Access Compliance Report

Public Rights-of-Way

Intersection ID: 4810	Main Street: BEN_CRAIG_DR	Cross Street: MALLARD_CREEK_RD	Location:	N
ADA ID: 8F81C60C848C	Ramp Type: Perpendicular	Initial Pass/Fail: Fail	Overall Compliance: No	Severity Score: 22.5

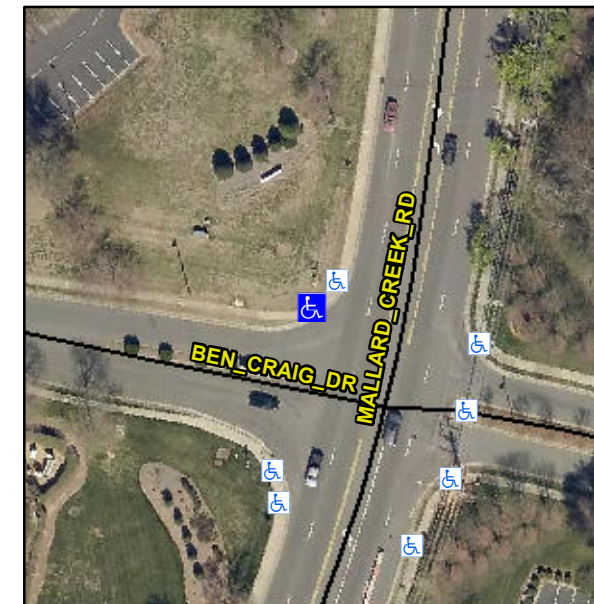
R304.5.1, R304.2.2, R304.5.3

Compliance	Description	Data	Compliance	Description	Data
N/A	Ramp Length (in)	61.0	No	Ramp Slope (%)	11.7
No	Ramp Width (in)	46.0	No	Ramp XSlope (%)	2.7
N/A	Flare Type LT	N/A	N/A	Flare Type RT	N/A
N/A	Flare Slope LT (%)	N/A	N/A	Flare Slope RT (%)	N/A
N/A	Flare Traversable LT?	N/A	N/A	Flare Traversable RT?	N/A
N/A	Landing Length (in)	N/A	N/A	DWS Provided?	N/A
N/A	Landing Width (in)	N/A	N/A	DWS Contrast?	N/A
N/A	Landing Slope (%)	N/A	N/A	DWS Length (in)	N/A
N/A	Landing X Slope (%)	N/A	N/A	DWS Full Width?	N/A
N/A	Landing Curb? (Y/N)	N/A	N/A	DWS Offset (in)	N/A
N/A	Shared Landing?	N/A			
N/A	Gutter Ponding?	N/A	N/A	Gutter Slope (%)	N/A
N/A	Gutter Lip Ht (in)	N/A	N/A	Gutter X Slope (%)	N/A
N/A	Painted X Walk1?	No	N/A	Painted X Walk2?	N/A
	X Walk 1 Direction	To SW		X Walk 2 Direction	N/A
N/A	X Walk 1 Width (in)	N/A	N/A	X Walk 2 Width (in)	N/A
	X Walk 1 Slope (%)	5.5		X Walk 2 Slope (%)	N/A
	X Walk 1 X Slope (%)	0.7		X Walk 2 X Slope (%)	N/A

Remove & Replace Entire Ramp.
